15-BSTD-01

Philips Lighting Comments on the Proposed Revisions to the California Building Energy Efficiency Standards California Code of Regulations, Title 24, Part 6 and Appendices; 45-Day Language

Comments for Proposed Language for 2016 Title 24 Part 06 & 2016 Joint Appendices

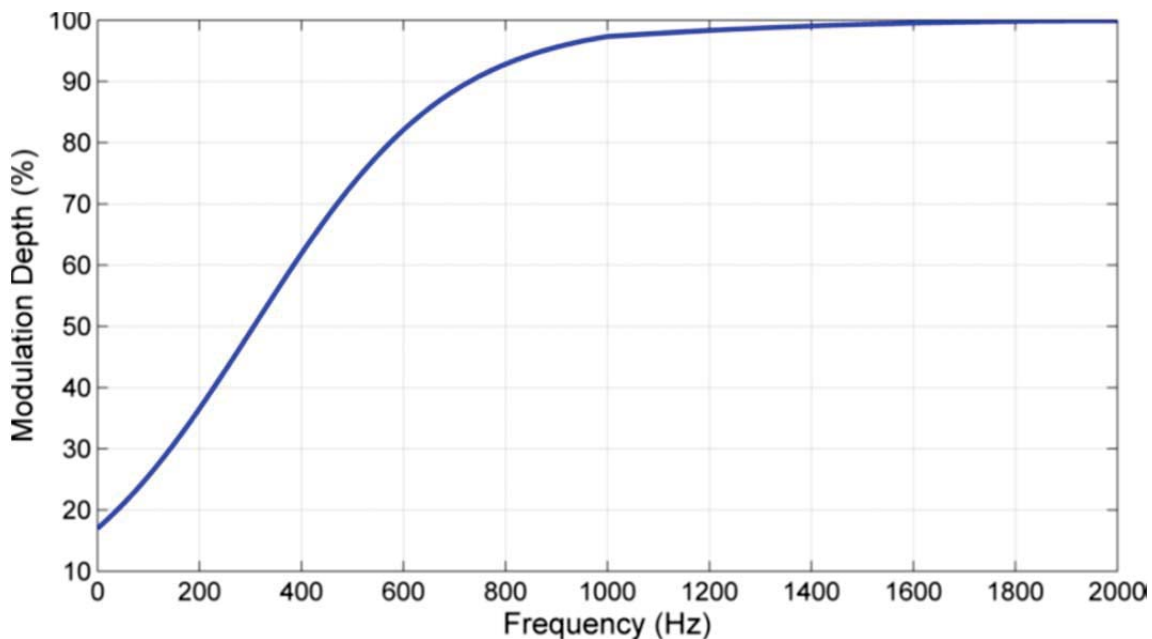
We continue to oppose over-specified performance parameters and requirements such as CRI >90, R9>50, SDCM<4 (or, in the case of JA8, $|Duv| < 0.0033$), CCT limited to <3000K, PF>0.9, minimum dim level <10%, start time < 0.3s (Note: this is given as 0.5s in JA8.4.3), and a 5 year warranty, as minimum requirements in code. The 2016 proposal widens the requirement for these over-specified parameters, both by increasing the number of specifications from 2013, and by its extended reliance on Appendix JA8. Table 150.0-A states that only LED must meet JA8. We do not support the CEC’s stance to have different performance specifications for different lighting technologies. We believe that none of these parameters should be stricter than ENERGY STAR for a minimum State specification.

We also question the need for rewriting ENERGY STAR specifications, such as Efficacy (JA8.3.1), Power Factor (JA8.3.2),..., Lumen maintenance (JA8.4.7), or Elevated temperature (JA8.4.8). JA-8’s restrictions on flicker, as summarized in Table JA8, are overly restrictive for some frequencies and too lax for others. The human eye definitely does not have a flat response over the range from 0 to 200 Hz.

This specification makes no allowance for the dependence of human flicker sensitivity either on frequency or on wave shape. For sine wave modulation, the visibility threshold for stroboscopic effects¹, expressed in terms of modulation depth, is shown in the figure below. At a particular frequency, modulation depths above the curve can be detected by most people. Below the

Zooming in on the region from 0 to 200 Hz in the figure above, the shaded rectangular region with dashed outline represents the conditions allowed by the Title 20 specification. The red triangle is forbidden by the Title 20 specification, but flicker in this region is not visible to most observers. Title 20, as a MINIMUM specification, should not exclude acceptable regions where flicker is not even be detected.

- We continue to oppose the over-specified performance parameters as defined in JA8, and strongly urge that any specifications on flicker and test procedures should wait until experts in this field (IEEE, NEMA and in IEC) conclude their work on this topic and produce a solid standard. It should be noted that ENERGY STAR is also collecting data on flicker and should complete their work and make recommendations to allow California to harmonize with the Energy Star specification.
- If the CEC is unwilling to remove the flicker specification and wait for alignment in standards organizations, then CEC should at the very least modify the present specification to allow use of the acceptable flicker region denoted by the red triangle in the figure above. We suggest modifying the specification to allow flicker in the region shown in the figure below:

The specification would then be: “Dimmer controls that can directly control lamps shall provide electrical outputs to lamps for reduced flicker operation through the dimming range so that the light output has an amplitude modulation below the line, Modulation Depth = 20% + Frequency/10, for frequencies from 100 to 200 Hz, without causing premature lamp failure.”
